Amendment on 29 June 2026

Arrangement Requirements for Combined Fire Detectors in Ro-ro Spaces and Special Category Spaces of Ro-ro Passenger Ships

Guidance for the Survey and Construction of Passenger Ships

ID:DX25-18

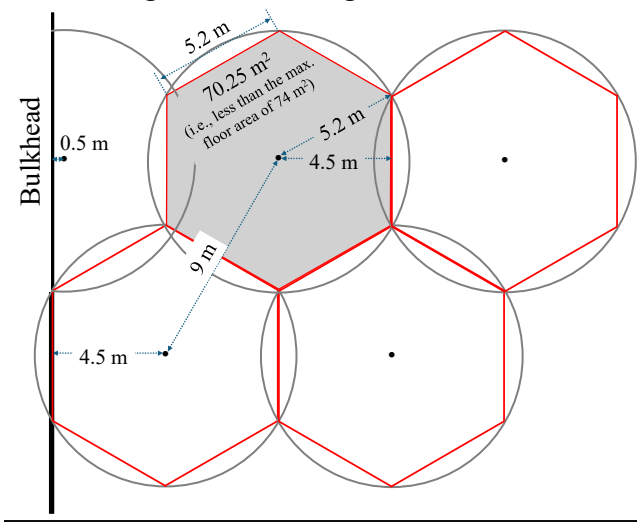
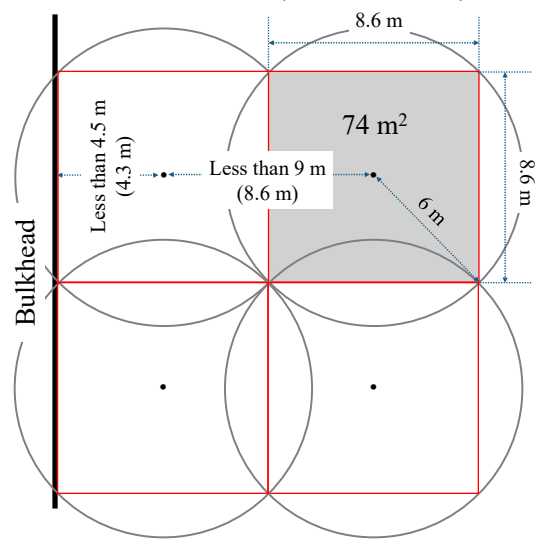
Adds reference examples of arrangements considered acceptable for combined detectors.

<table><tr><th>Number</th><th>FSS Code</th><th>Interpretations</th></tr><tr><td>FSS 9.2.4.2.2 & Table 9.1</td><td><u>The maximum spacing of detectors shall be in accordance with the table below*:</u></td><td>*: <u>The arrangement of combined smoke and heat detectors may be based on either (1) or (2) (See MSC.1/Circ.1695):</u> <u>(1) Arrangement based on the maximum permissible centre-to-centre distance of 9 m (See Fig. 7-1-B3(1)).</u> <u>(2) Arrangement based on the maximum permissible floor area of 74 m² (See Fig. 7-1-B3(2)).</u></td></tr></table>
